**Title: Glenmore Trail & Deerfoot Trail Interchange, Use of Normal Crown on Horizontal Curve with R4000 and Design Speed of 110 km/hr**

Memorandum Date: June 16, 2011

Design Exception Request Date: May 17, 2011

DEERFOOT TRAIL SB LANES - CROWN CORRECTION DETAIL  
1:250

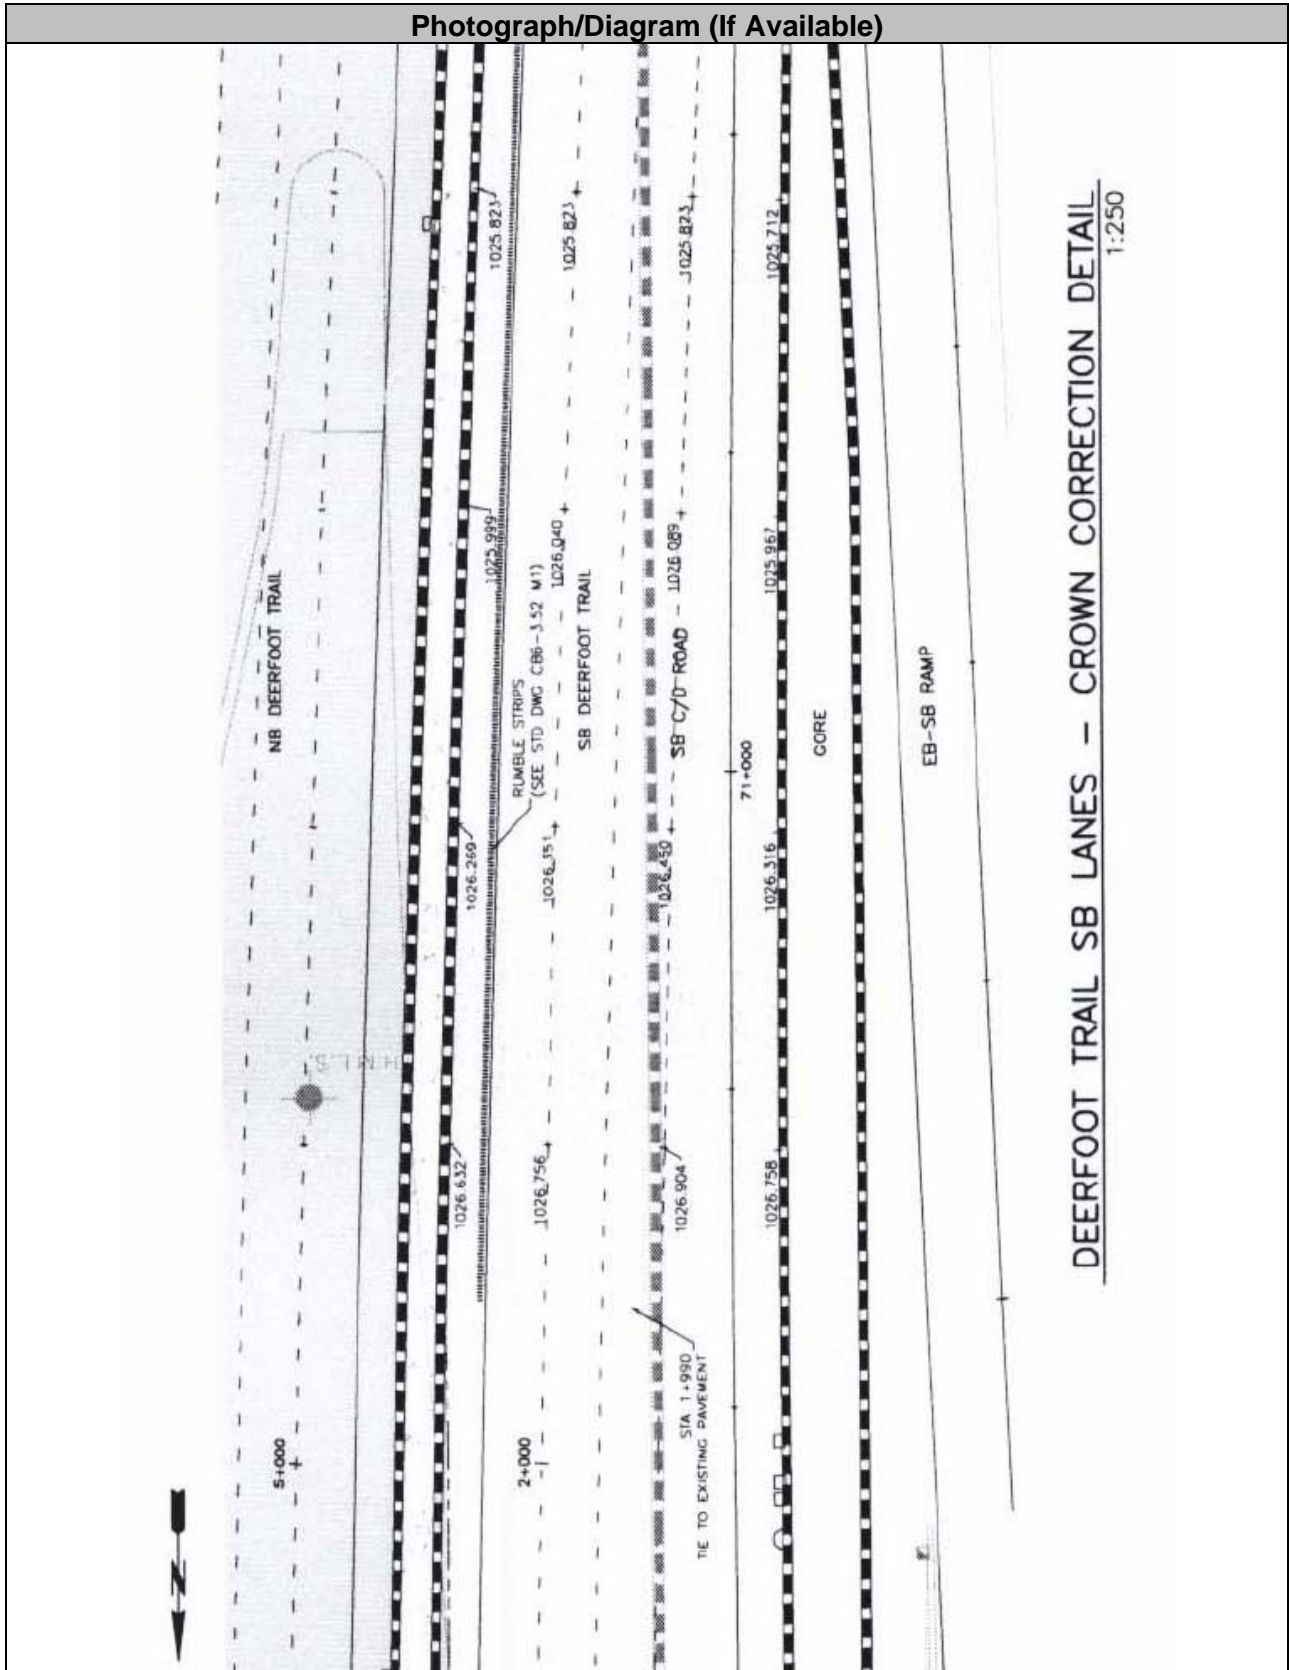
A request to use a normal crown along a horizontal curve with a radius of 4000m and a design speed of 110km/hr.

- The calculated side friction factor value for the normal crown is 0.0438 which is less than the maximum safe side friction factor of 0.10 for a design speed of 110 km/hr according to Alberta Transportation's Design Guide.
- Based on AASHTO's superelevation calculation Method 1, the minimum radius for a design speed of 110 km/hr with a normal crown is 3,500m which is less than the proposed 4000m radius for this curve.
- By applying the normal crown along this curve, the project cost savings will be \$90,020.
- No significant impacts or risks anticipated other than a slight risk of overdriving along the horizontal curve. Overdriving is being addressed with the addition of rumble strips

Rumble strips will be installed along the inside shoulder of this curve.
